CITY PLANNING COMMISSION

APPLICATION: 1. Negative Declaration
2. Lot Line Merger to create a 0.5± acre parcel in the Light Industrial (M-1) zone.

LOCATION: 1100 'C' Street

APPROVING A LOT LINE ADJUSTMENT
TO MERGE THE NORTH 120 FEET OF LOT 1
AND WEST 40 FEET OF LOT 2 OF THE BLOCK
BOUNDED BY 11th, 12th, C AND D STREETS
OF THE OLD CITY (P84-133)

EXHIBIT A

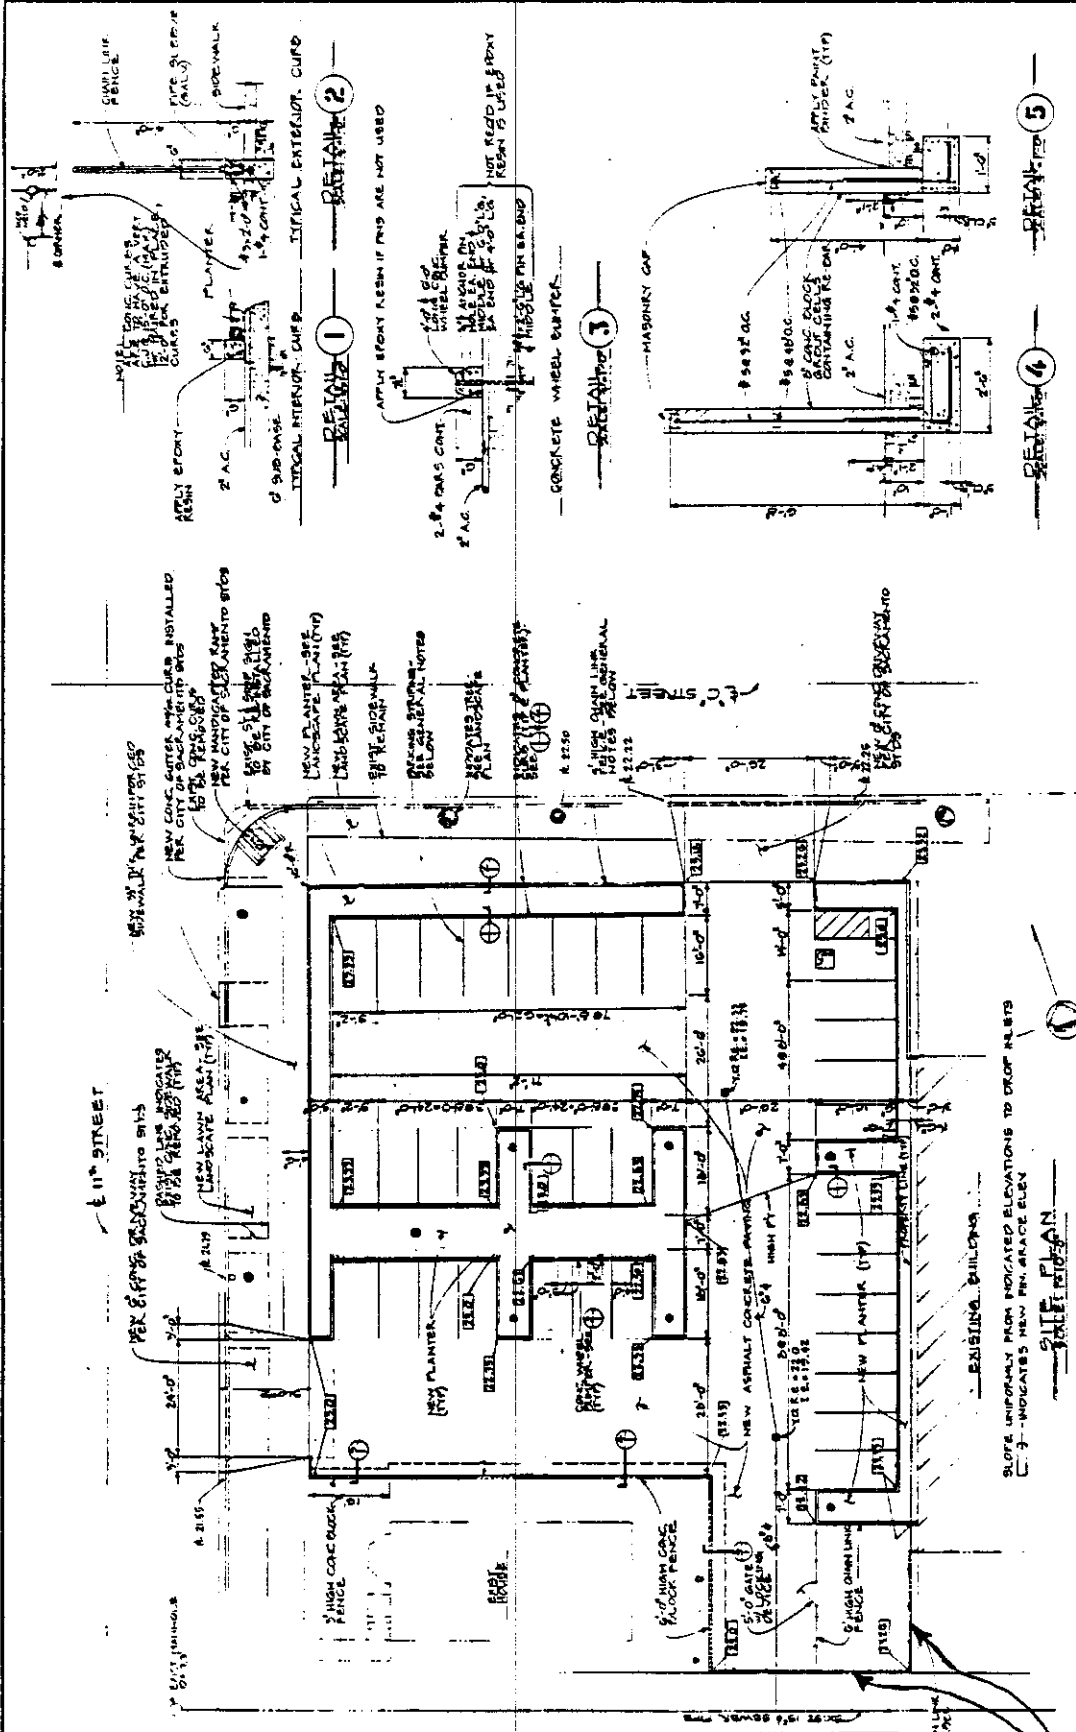
1. The applicant shall submit closure calculation for each parcel and overall boundary of the site. It shall be prepared by a certified licensed land surveyor or civil engineer and reviewed and approved by the City Engineer's Office.
2. The proposed lot lines are to be monumented.
3. A new legal description shall be submitted to the City Engineer for review and approval.

EXHIBIT B

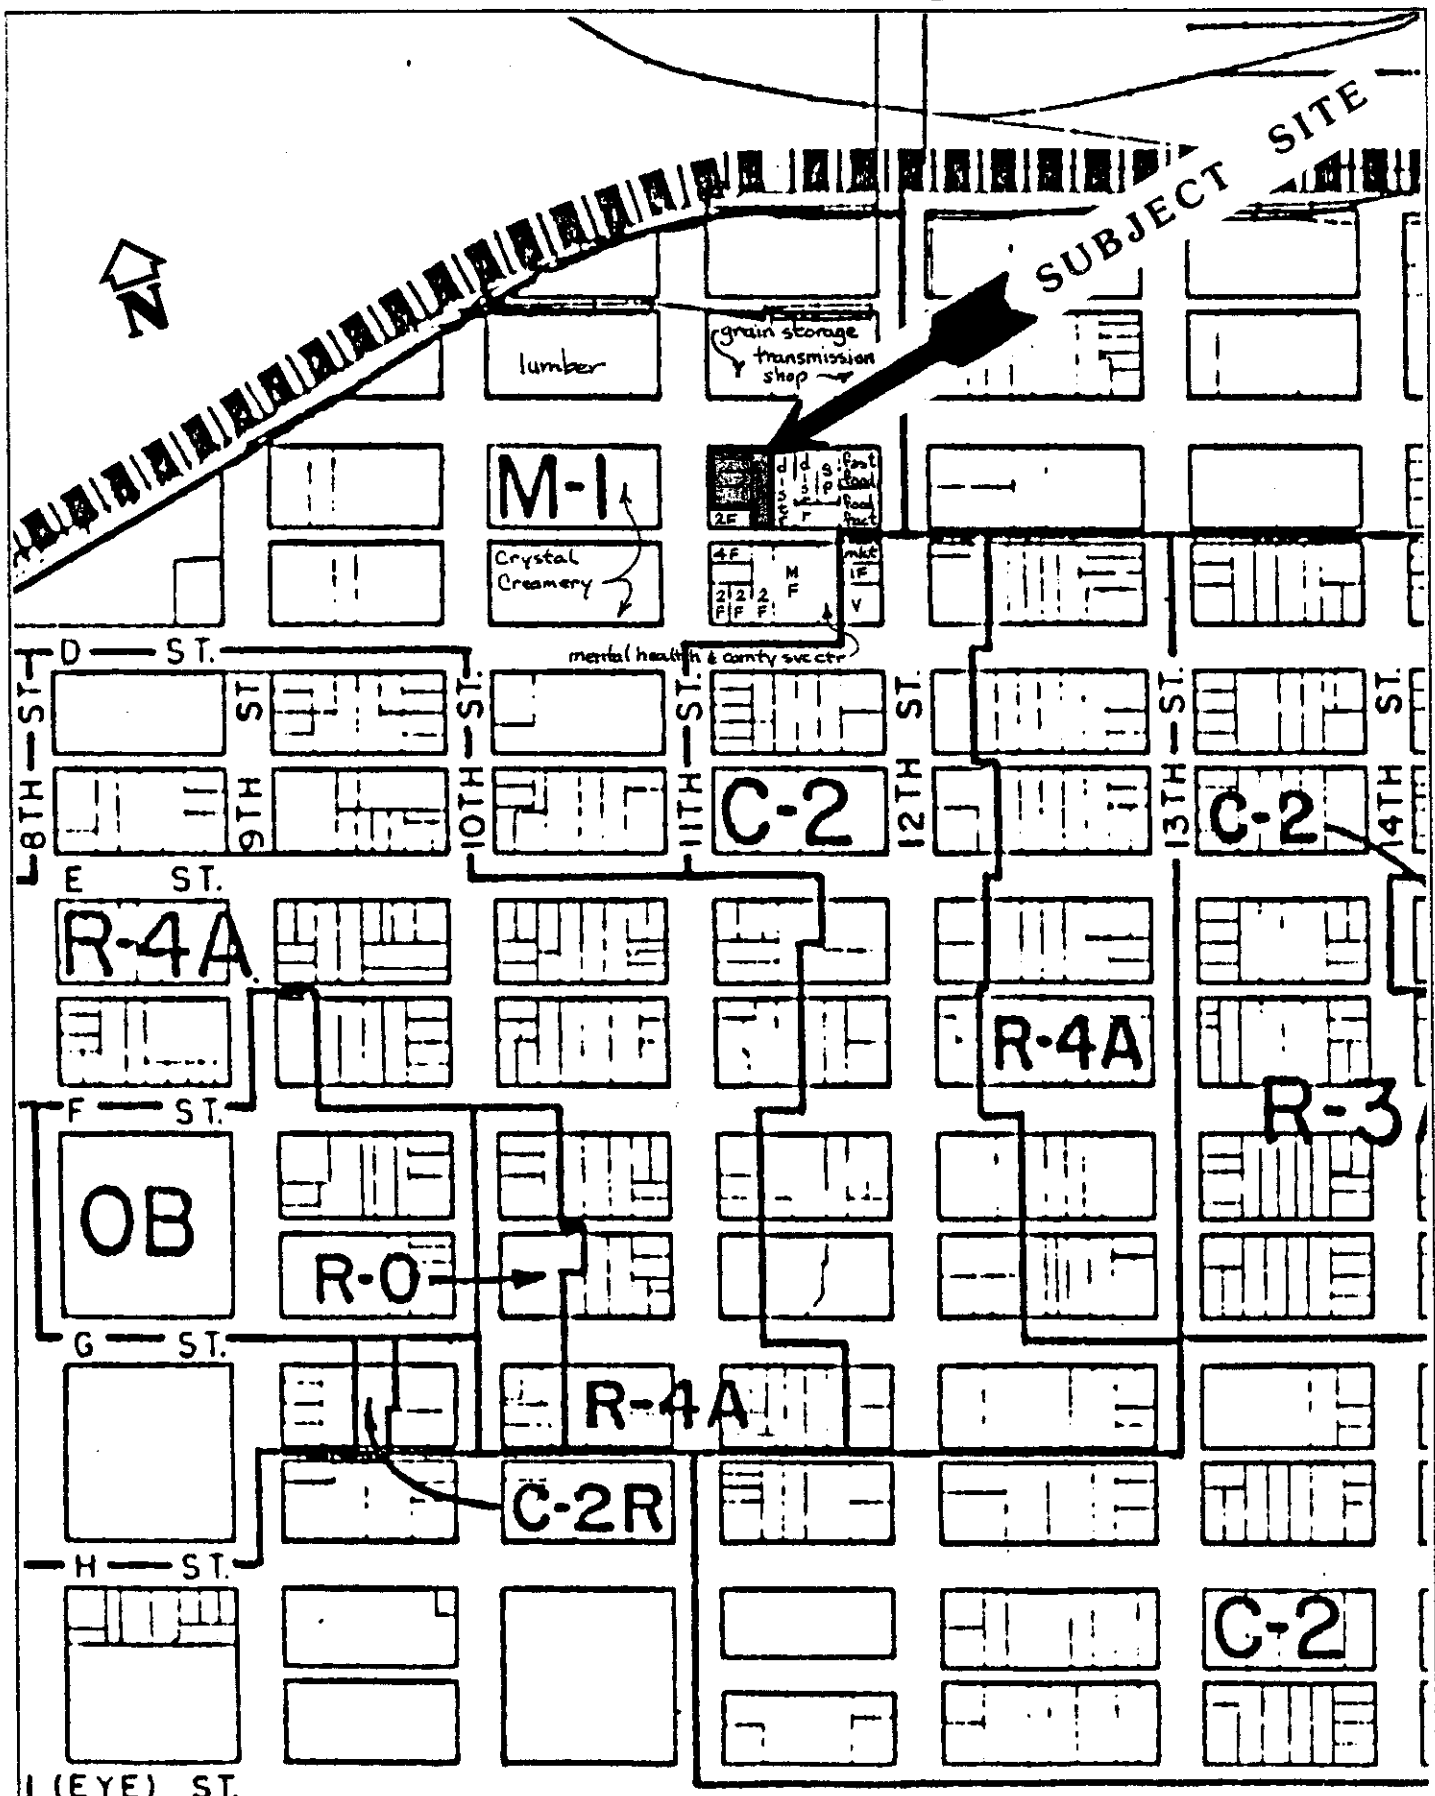
1. The subject site is comprised of five vacant parcels in the Light Industrial (M-1) zone. Residential structures had previously been located on these parcels.
2. The parking lot is proposed as supplemental off-street parking for Crystal Creamery employees.
3. The six-foot chainlink fence along the alley (see the parking lot plan, Exhibit B) is not in compliance with the Zoning Ordinance. The applicant should be aware that a six-foot masonry wall is required due to the existing residential use on the south side of the alley.

The remaining six-foot chainlink fencing along the alley end of the east property line is indicated with barbed wire at the top. The fencing regulations prohibit fencing exceeding six feet in height, except by approval of a Planning Director's Variance and issuance of a building permit.

STAFF COMMENTS:

- 1) 6 FT. MASONRY WALL REQ'D ALONG ALLEY PER ZONING ORD.
- 2) PLANNING DIRECTOR'S VARIANCE & BUILDING PERMIT REQ'D FOR FENCING EXCEEDING 6 FT IN HT.

Compliance with these fencing regulations will be verified at the time of Building Division inspection of the parking facility.
